**NOTICE OF A REGULAR MEETING
BONDURANT PLANNING AND ZONING COMMISSION
NOVEMBER 9, 2023**

TITLE: Resolution considering recommended approval of Dollar Tree First Addition Final Plat.

TITLE: Resolution considering recommended approval of Dollar Tree Site Plan.

TITLE: Resolution considering recommended approval of Campus Industrial Park Preliminary Plat.

Sheet
L01

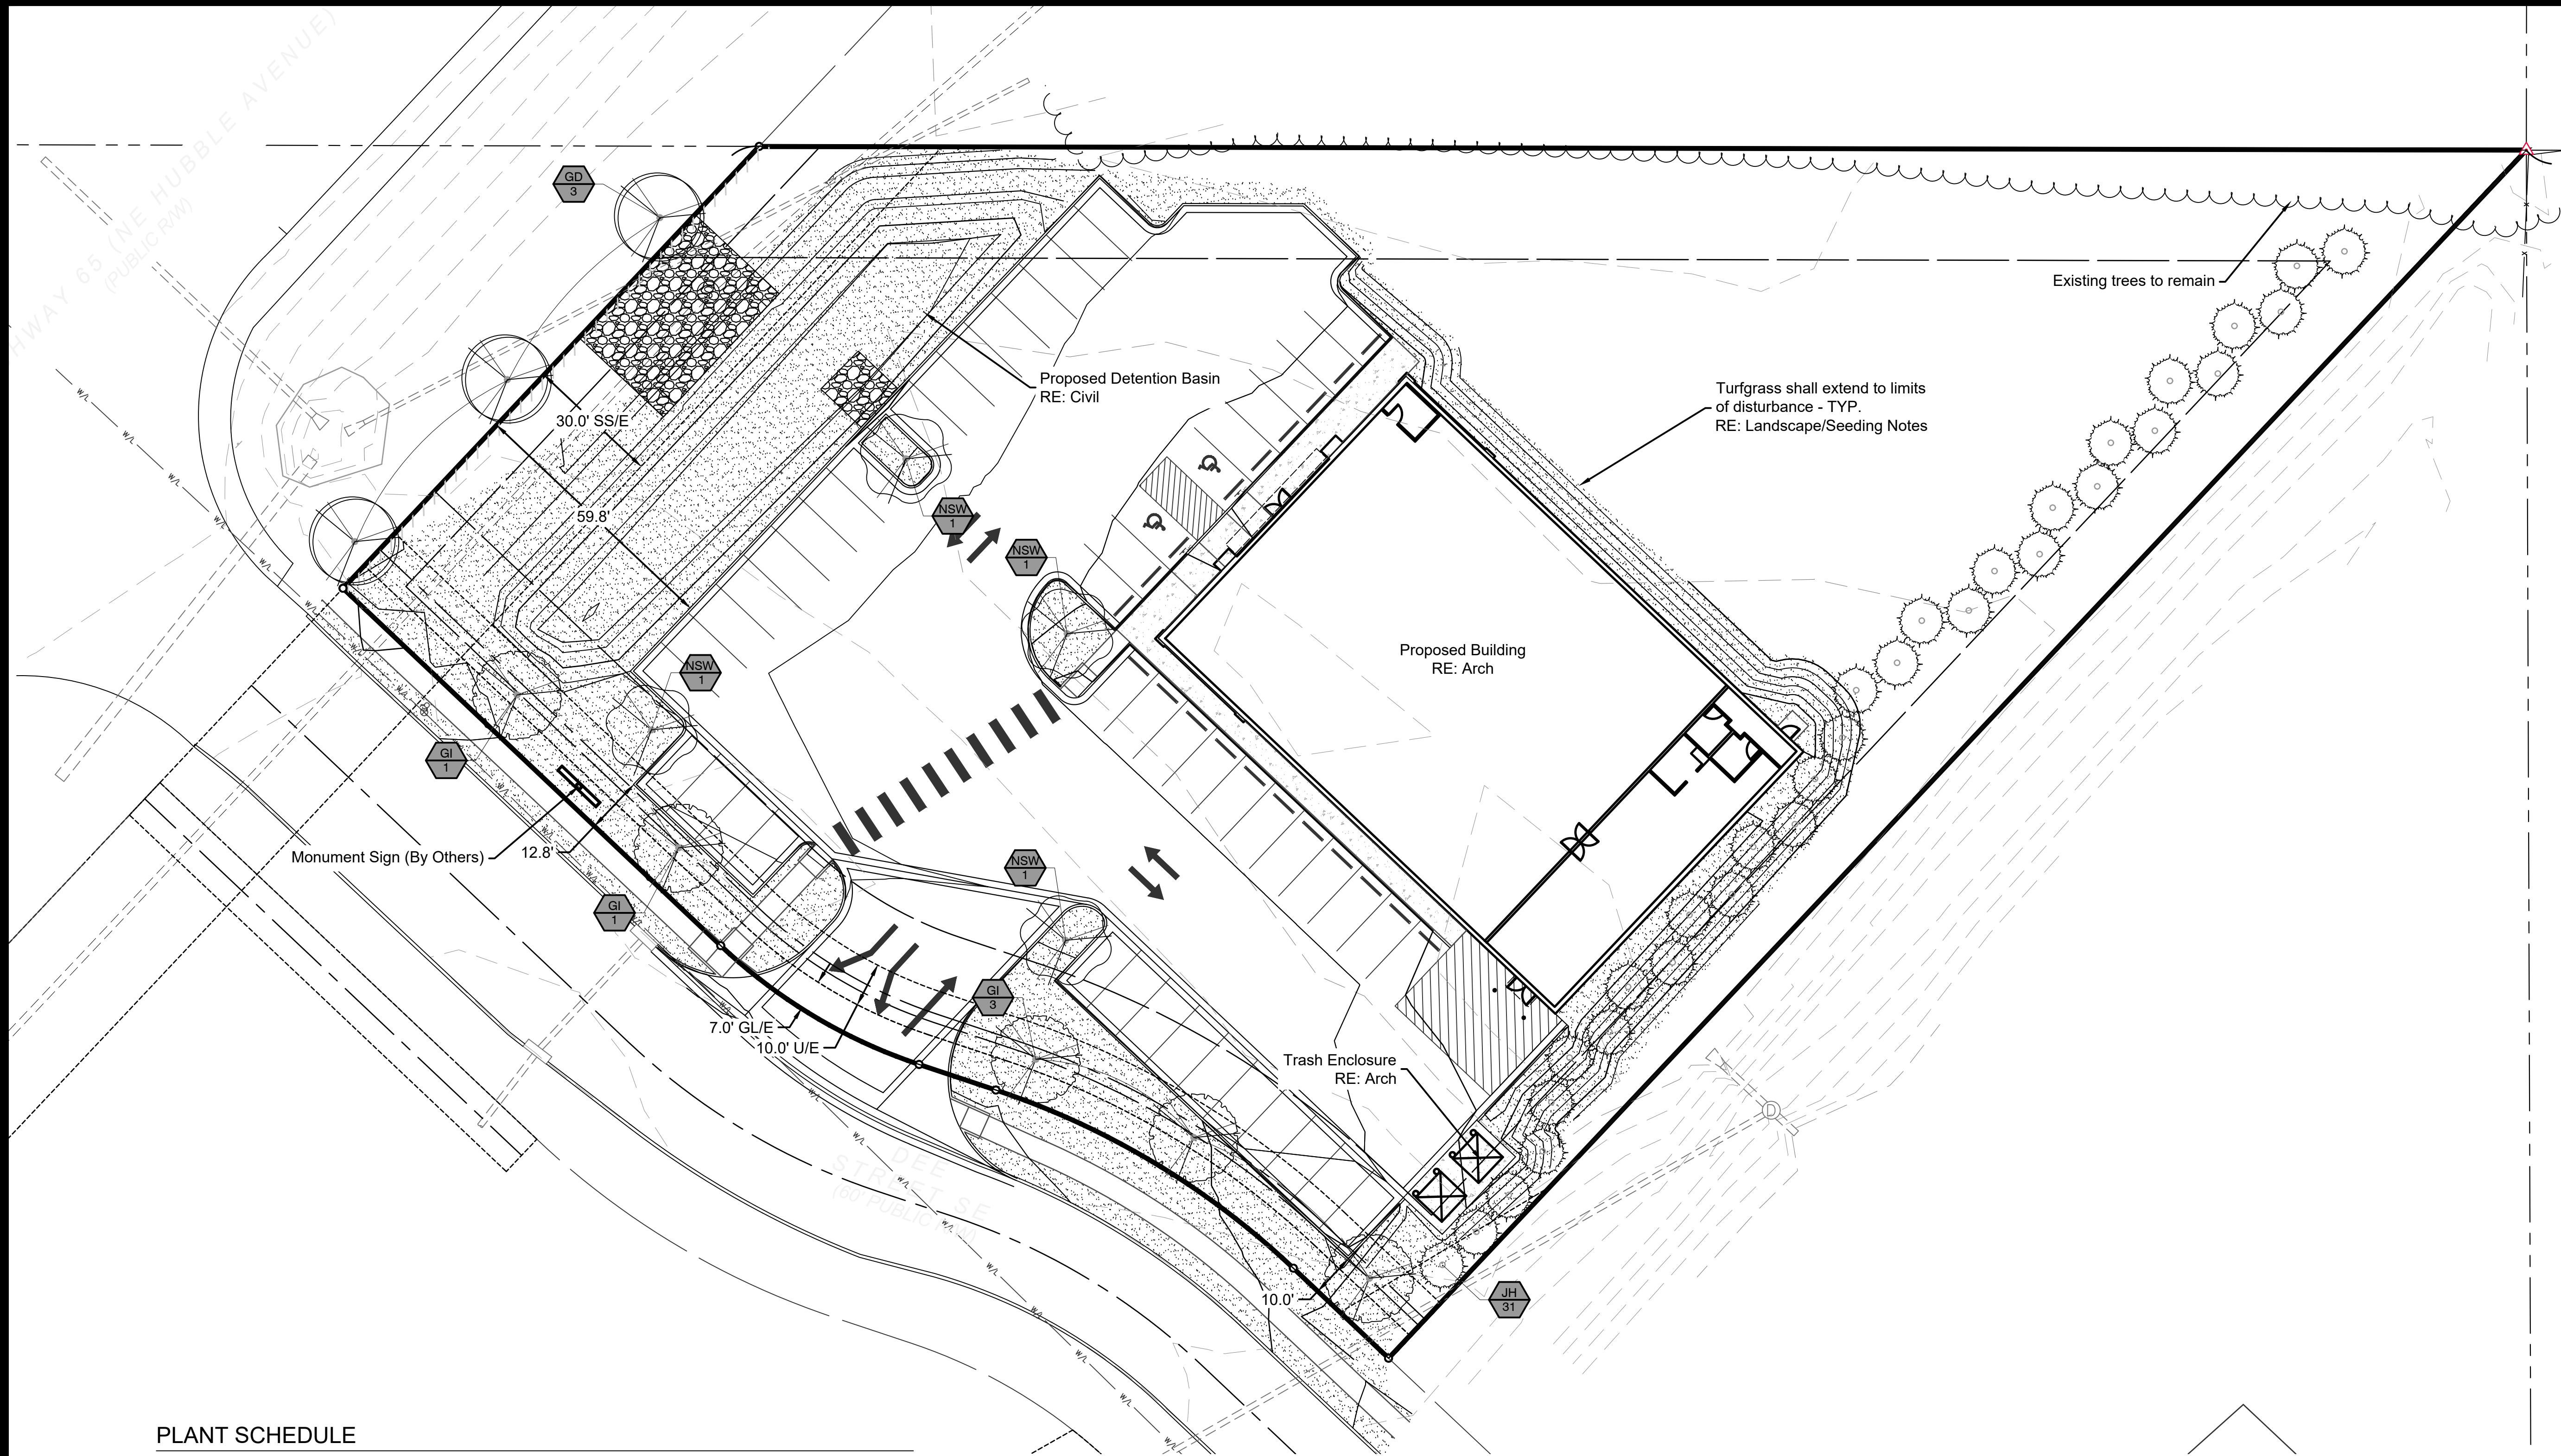
- Per Section 182.04 for every 50' of street frontage a property has 1 tree must be planted in the front setback area. The site plan shows 8 general trees, 5 of which are planted in the front yard setback area adjacent to Dee Street SE. 3 trees are currently shown planted in the Hubbell Avenue right-of-way area. These trees are planted in this area due to the applicant's concerns regarding an existing

FILE PATH: J:\2022 Projects\22-090 Bondurant Rose Annexation\Engineering\Sheet Set C-1 - Cover Sheet

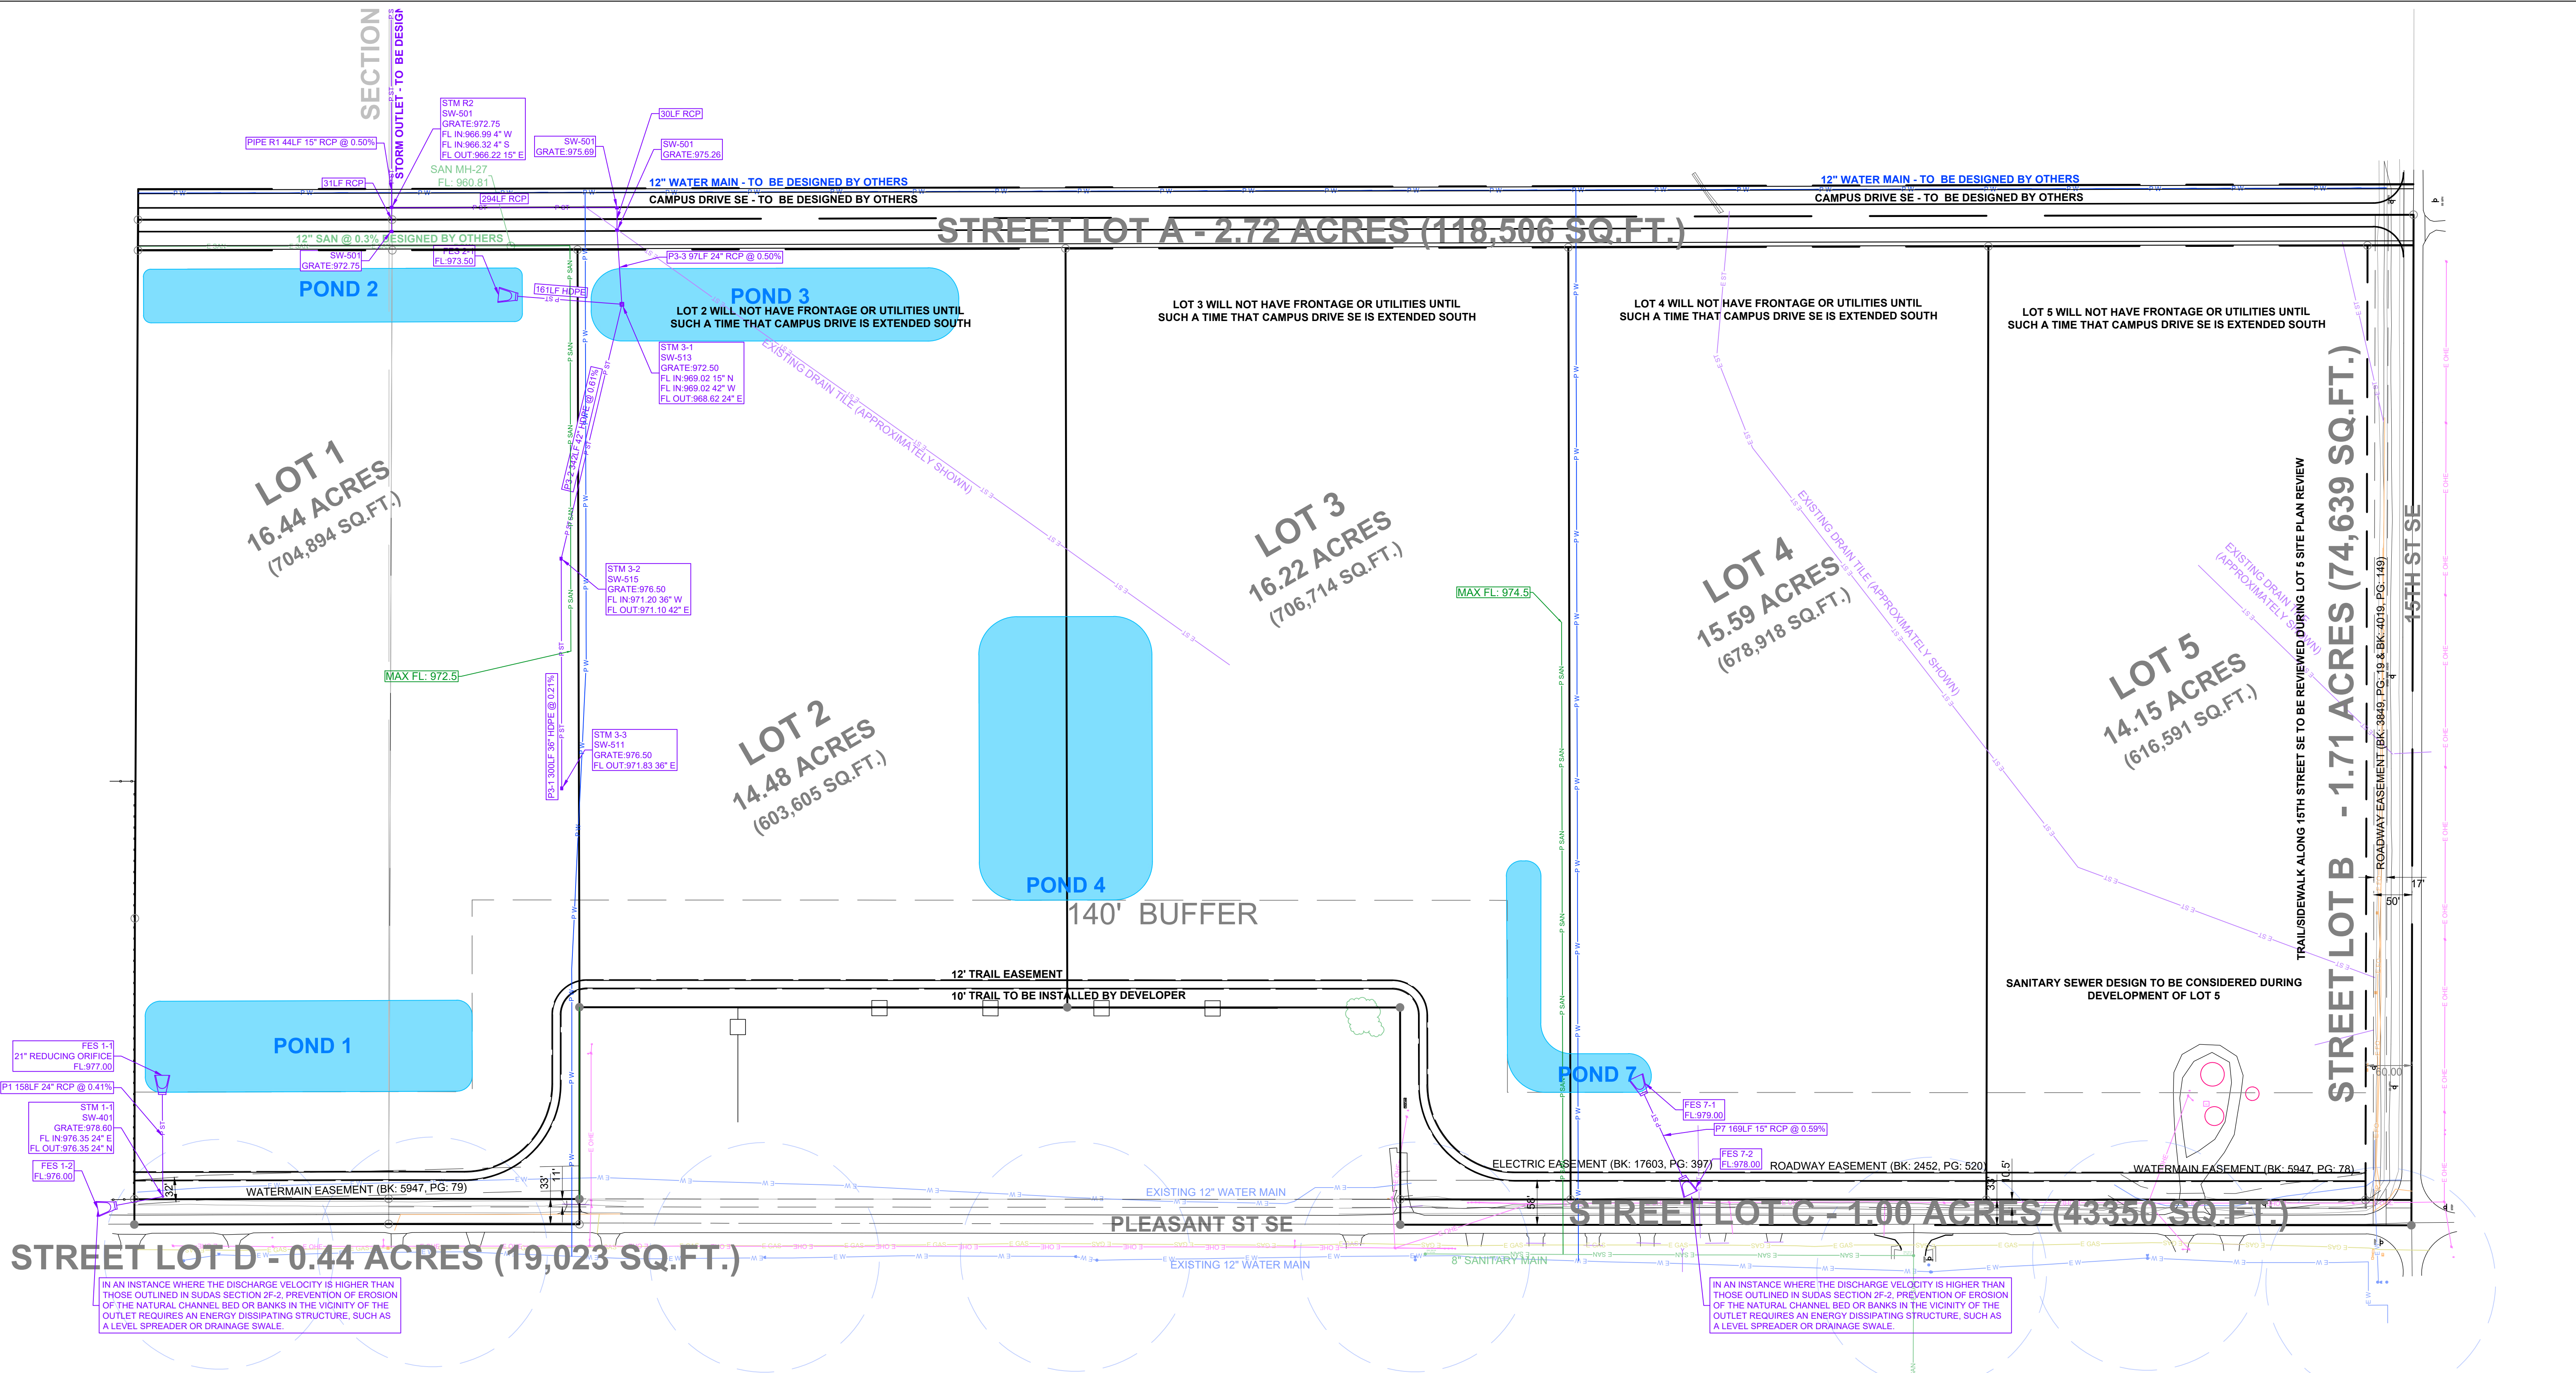
These bulk regulations are reflected on the submitted preliminary plat. The plat shows a 140’ buffer area between the industrial lots and Pleasant Street SE and/or the residential properties adjacent to Pleasant Street SE. The 140’ buffer area is zoned A-1 Agricultural which is reflected in green on the Zoning Map below. M-1 Limited Industrial is shown in light blue on the Zoning Map below. The Campus Industrial Park Preliminary Plat is highlighted below on the City’s Zoning Map.
